SUBJECT: Forwards revised FSAR figures documenting analyses of SER
 Confirmatory Issue 1 re final pipe break locations & design
 of pipe whip restraints. Final break locations based on
 completion of as-built programs & final stress analysis.

August 8, 1983
G02-83-705

Subject: NUCLEAR PROJECT NO. 2
SAFETY EVALUATION REPORT, CONFIRMATORY
ISSUE (1) BREAK LOCATIONS

The subject confirmatory issue requires submittal of the results of analyses to determine final pipe break locations and final design of pipe whip restraints. Attached are the revised FSAR figures documenting these analyses. It should be noted that these revisions indicate break locations based on the "status as built" stress analysis with thermal and fatigue loads. The "status as built" is not a final "as built" configuration; however, the Supply System does not anticipate any significant differences. Hence, the stress analysis and resulting pipe break locations in the attached figures, although not based on a final "as built", will not differ significantly from the final break locations. The final break locations will be based on completion of the "as built" program and the final stress analysis. Although no changes ar

FIG 3.6-34b

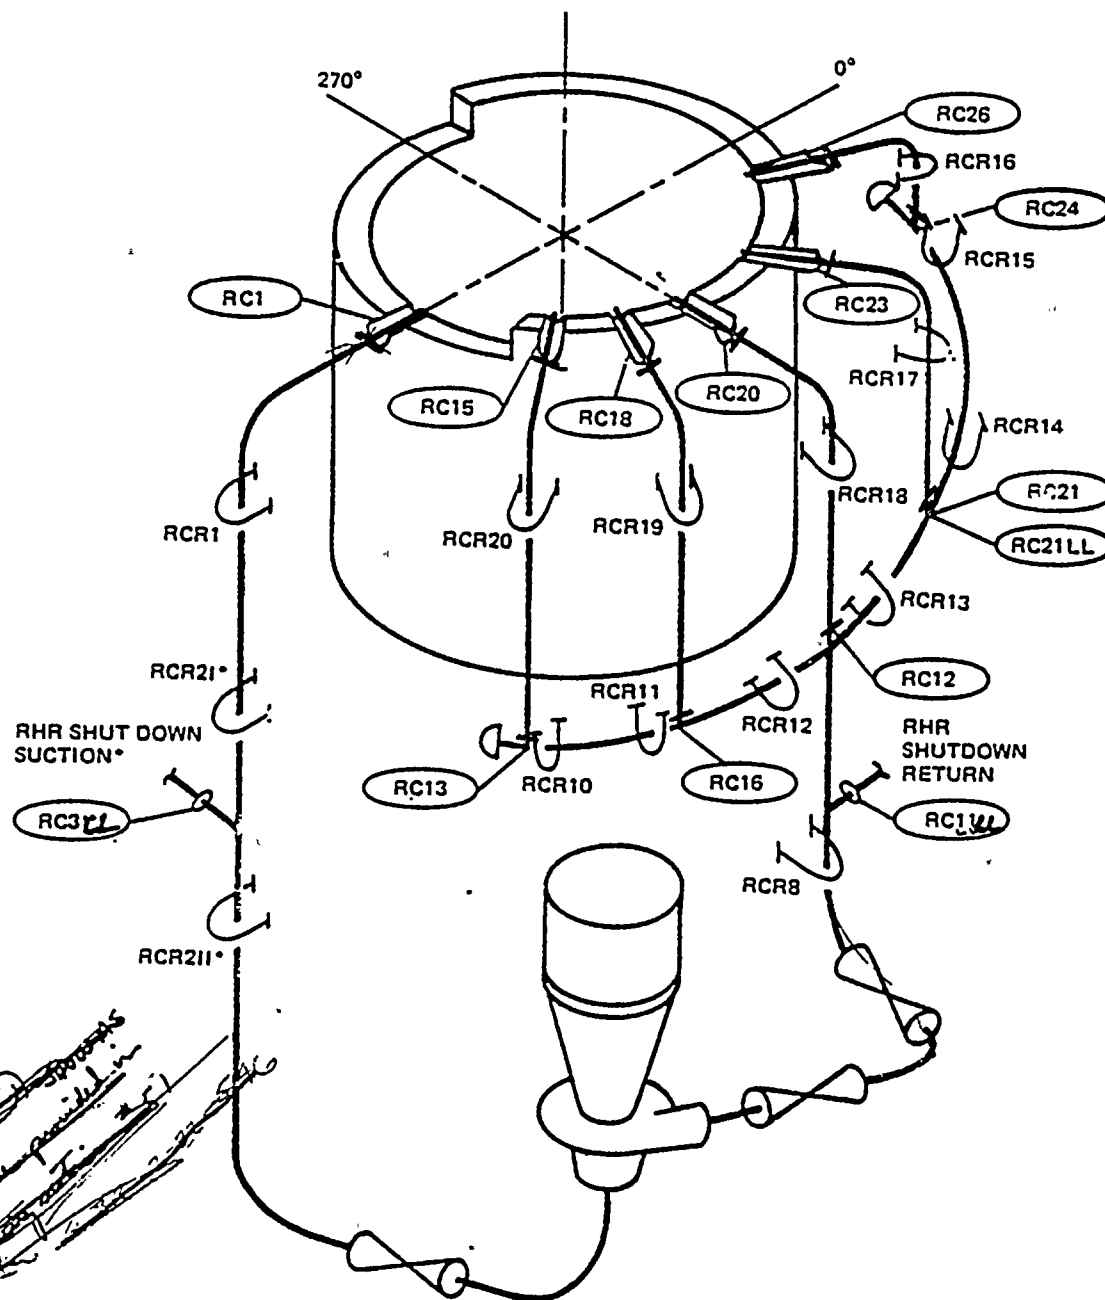
SUMMARY OF POSTULATED PIPE BREAK
LOCATIONS.

CIRCUMFERENTIAL BREAKS

NODE 11
NODE 12
NODE 41
NODE 42
NODE 9
NODE 37

LONGITUDINAL BREAKS

NODE 11A
NODE 41A
